SUBDIVISION COMMITTEE
METROPOLITAN AREA PLANNING COMMISSION

STAFF REPORT
(Preliminary Plat Deferred from 9/3/98)

CASE NUMBER: S/D 98-84 - CHAPEL HILL ADDITION

STAFF REPORT
(Final Plat, Preliminary Plat Approved 9/17/98)

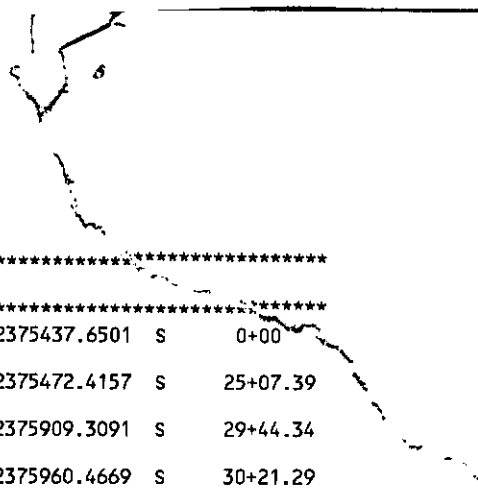
- G. The distance to the northernmost lots is approximately 3,000 feet; in excess of the 600 foot maximum noted in the Subdivision Regulations for cul-de-sac access. Currently, the proposed street stub to the west does not have any connection and Fire Department needs to comment on a potential emergency access easement for a second point of access to this plat. City Fire Department requires a second point of access. Applicant has agreed to include an emergency access easement.

The final plat has included the requested emergency access easement; however it should be extended northward to connect with Crestwood Street.
